VARIANCE APPLICATION

PROPERTY INFORMATION			
Project/Property Address: 1379-1391 Johnstown Rd.		Project Name/Business Name: Roger's Market Limited	
Parcel #: 025-009559-00	Zoning: (see Map) NC	Acreage:	2.967

CITY OF GAHANNA, FRANKLIN COUNTY, OHIO DESIGN REVIEW PLAN FOR THE MARKET AT ROGER'S CORNERS PARKING EXPANSION 2023

STAFF REPORT

CITY OF GAHANNA, FRANKLIN COUNTY, OHIO
 DESIGN REVIEW PLAN
FOR
THE MARKET AT ROGERS'
CORNERS
 SITE PLAN

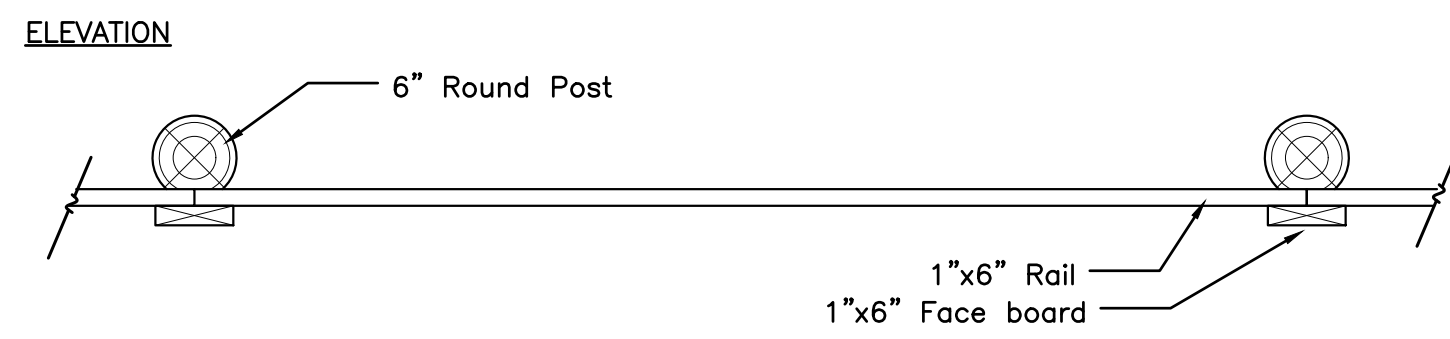
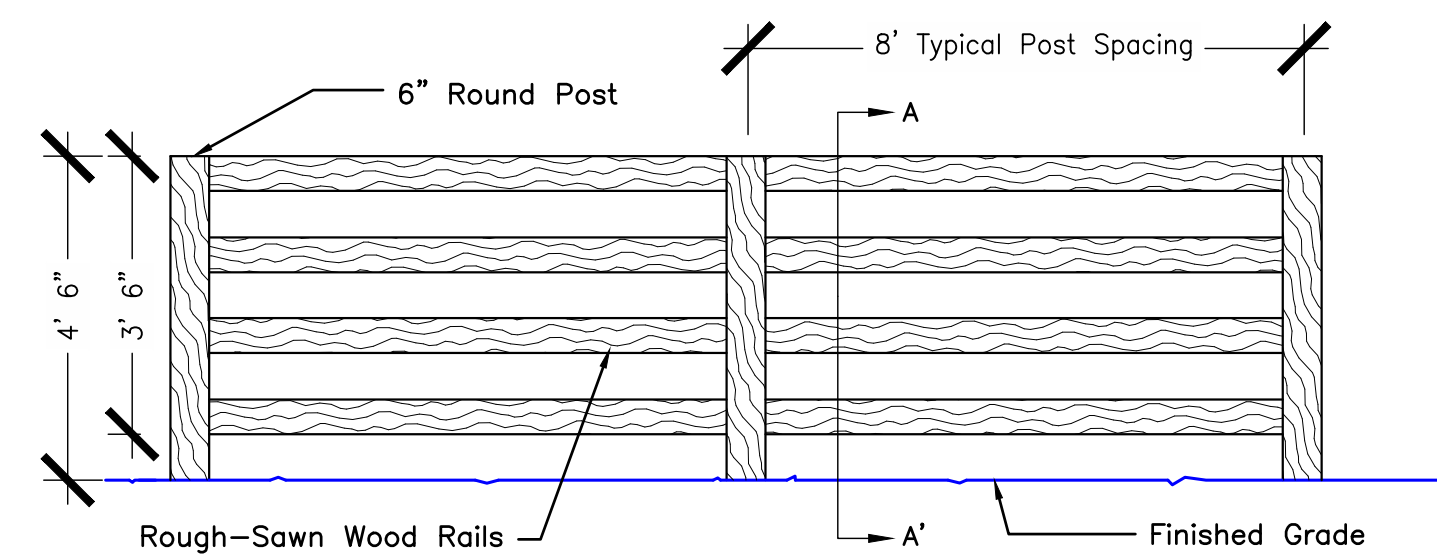
VARIANCE SPECIFICATIONS
Description of Variance Request: Requesting variances to allow parking spaces that are 9ft in width, a front yard and parking setbacks as shown on the site plan and a variance so that 10' wide landscape islands are not required. Please see attached.
STAFF USE ONLY: (Code Section): Chapter 1163.01(a) - Parking space size; Chapter 1163.08(h) - Interior landscaping; Chapter 1167.15(b) - Parking setback

- Chapter 1163.01(a) – Parking space width
 - 9' requested; existing parking spaces are 9' wide
 - 10' required by code
- Chapter 1163.08(h) – Interior landscaping

- Code requires there be a ten foot wide landscape island between two rows of parking
 - Existing parking does not meet this requirement
- It should be noted that staff is working on code changes to eliminate this requirement. Similar projects have received variance approval.
- Chapter 1167.15(b) – Parking setback
 - Code requires a 36’ setback from right-of-way
 - Existing parking does not meet this requirement
 - The city is working with multiple jurisdictions to vacate unnecessary right-of-way along the northern property line. The proposed parking improvements along the northern property line may not meet setback requirements, however, the parking is setback from pavement at a far greater distance than typically found in Gahanna. The City believes that the reduced setback will not create an unsafe condition along Morse Rd.
